<b>Title - Sujet</b> LEONARD J COWLEY VLE REFIT- 2015	
<b>Solicitation No. - N° de l'invitation</b> F7049-140286/A	<b>Amendment No. - N° modif.</b> 009
<b>Client Reference No. - N° de référence du client</b> F7049-140286	<b>Date</b> 2015-01-26
<b>GETS Reference No. - N° de référence de SEAG</b> PW-\$\$MD-021-24828	
<b>File No. - N° de dossier</b> 021md.F7049-140286	<b>CCC No./N° CCC - FMS No./N° VME</b>
<b>Solicitation Closes - L'invitation prend fin</b> <b>at - à 02:00 PM</b> <b>on - le 2015-02-09</b>	<b>Time Zone</b> <b>Fuseau horaire</b> Eastern Standard Time EST
<b>F.O.B. - F.A.B.</b> <b>Plant-Usine:</b> <input type="checkbox"/> <b>Destination:</b> <input type="checkbox"/> <b>Other-Autre:</b> <input type="checkbox"/>	
<b>Address Enquiries to: - Adresser toutes questions à:</b> Byron, Dan	<b>Buyer Id - Id de l'acheteur</b> 021md
<b>Telephone No. - N° de téléphone</b> (819) 956-0691 ( )	<b>FAX No. - N° de FAX</b> (819) 956-7725

**Solicitation Amendment #9 is issued to:**

CCGS Leonard J. Cowley – VLE Refit 2015  
PWGSC File Number: F7049-140286  
Bidder Conference  
280 Southside Rd, St. John's NL  
Gilbert Room  
1 PM, Thursday January 15, 2015  
**Meeting Minutes**

## H-11 – Additional Information

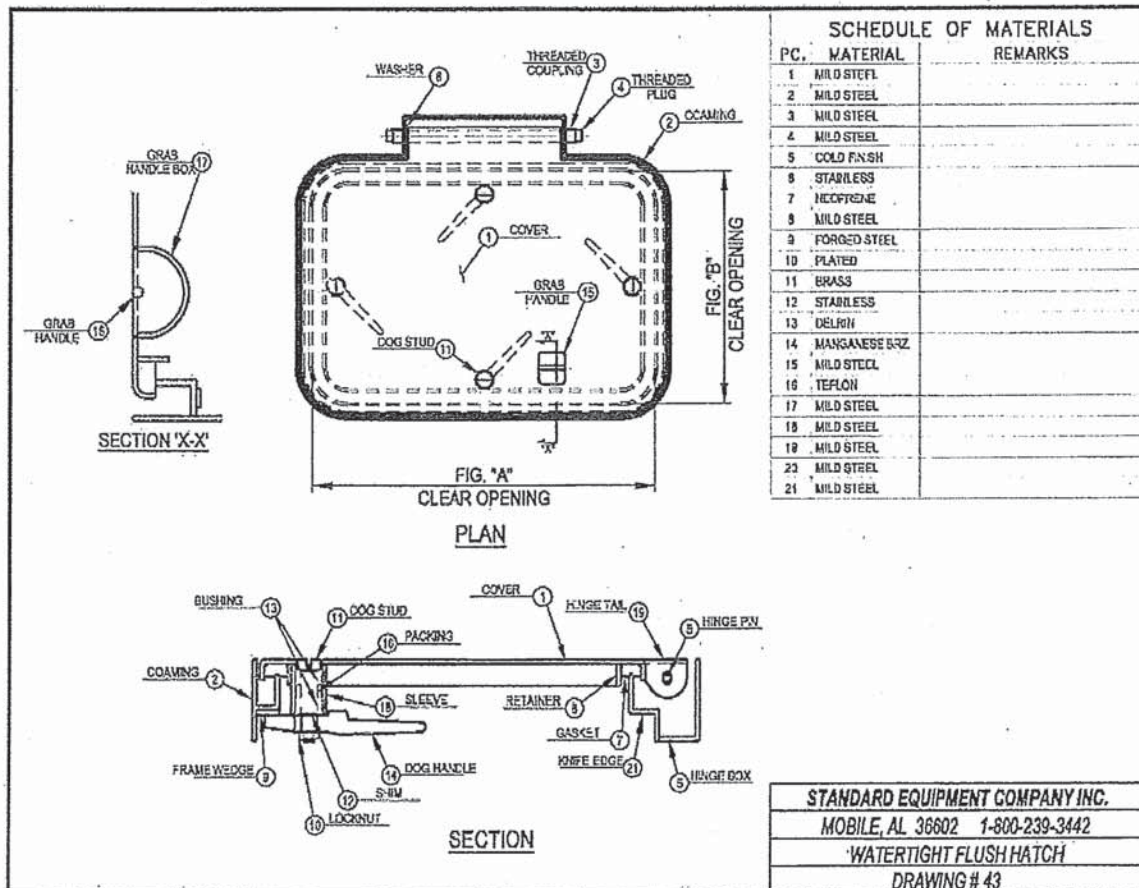
- Bidder asked if drawing is available for the access hatch, and is the specification for the replacement hatch also available. CCG: Drawings with details were supplied. Must be Lloyds approved. Bidder to use drawings provided for details. Sufficient detail is provided on the drawing 102-08-02 Helicopter Refueling System Access Hatch for bidding purposes.

**POST MEETING NOTE:** Addition information for hatch and rollers for the hatch supplied
